## **Final engineering report for wastewater treatment facilities for the Kennecott Flambeau Project. 1989**

RE: Flambeau Project  
Final Engineering Report for Wastewater Treatment  
Facilities

Review comments from Ms. Percy Mather of the WDNR regarding the Preliminary Engineering Report (PER) were considered in preparing the FER. As an aid in the review process, we have listed her comments below and indicated our responses and/or the location of the response in the FER.

**FIGURE NO. 8**  
**SETTLING POND**  
**HYDRAULIC PROFILE**

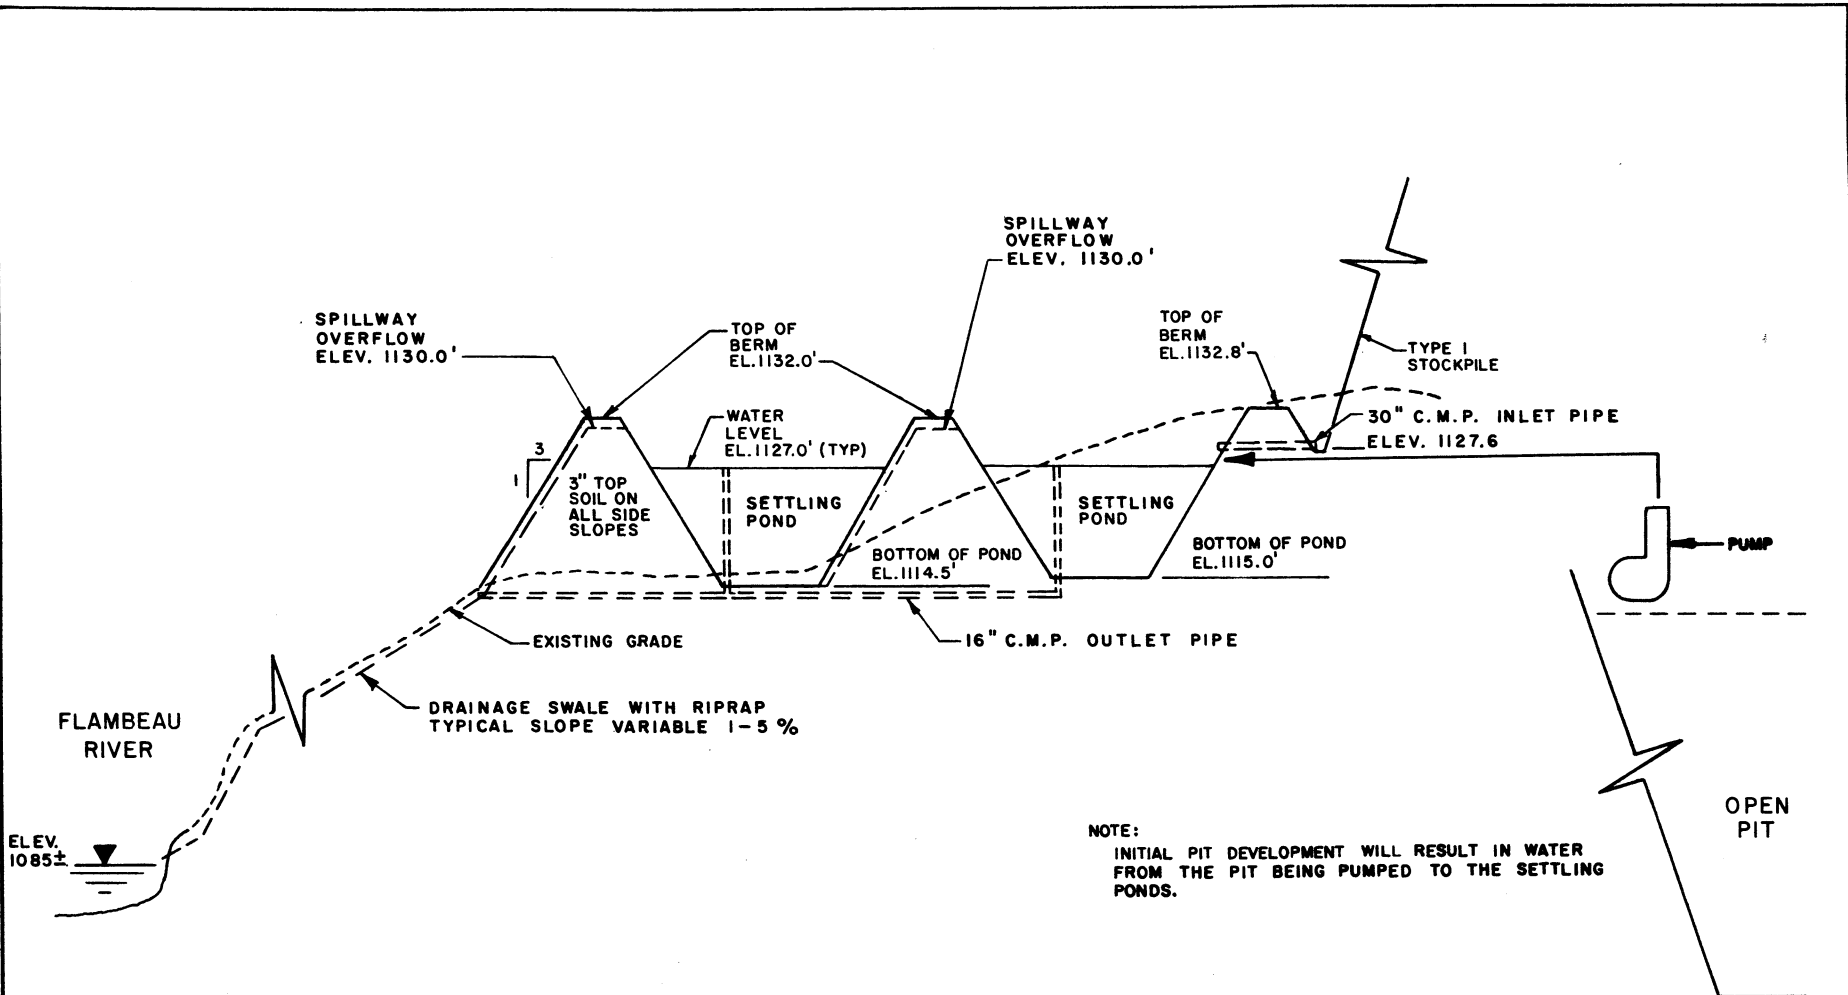
Comment No. 9

- A. Operation and Maintenance plan;
- B. Hydraulic profile of the settling pond configuration;
- C. Piping diagram of the system including the polymer feed system; and
- D. A description and/or sketch of the spillway structure.

Response No. 9

- A. An operation and maintenance plan was included in the PER, however, the plan has been modified in the FER to include more details. A discussion of the revised operation and maintenance plan can be found in Section 6.3.2 of the FER.
- B. An additional drawing (Figure No. 8) has been prepared illustrating the hydraulic profile of the settling ponds.
- C. The only piping associated with the settling ponds are the 36 inch outlet structure and the 16 inch discharge structure. A plan view and section showing this piping are included in Figure No's. 3 and 9 of the FER. There are no provisions for polymer feed in the settling ponds at this time. When operated as a retention pond, the polymer will be fed manually, if needed. A more detailed discussion of this process can be found in Sections 6.3.1 and 6.3.2 of the FER.
